GZEM1511005894CR
Modification Method

Product Name: Remote car

Product NO.: SP6888-2

Radiated Emission

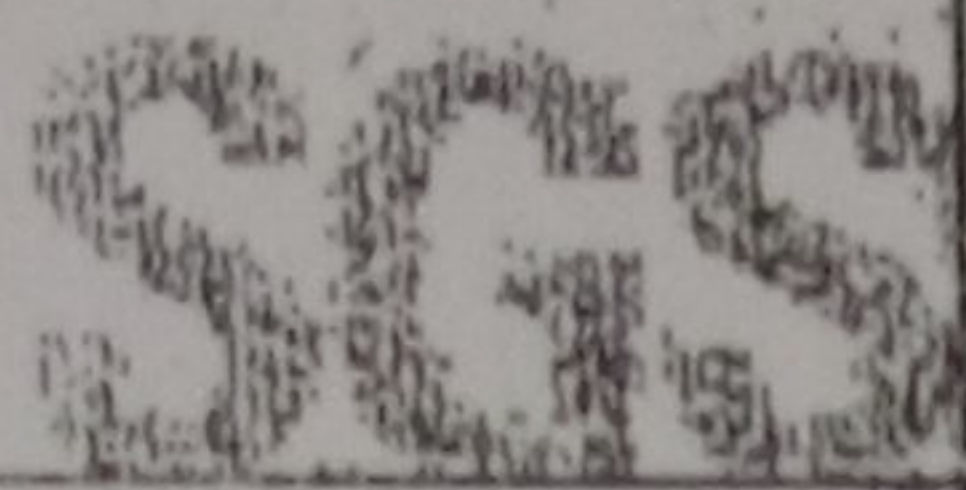
1. Add one capacitor C2 with new one which capacitance is 47pF as the following figure shown.
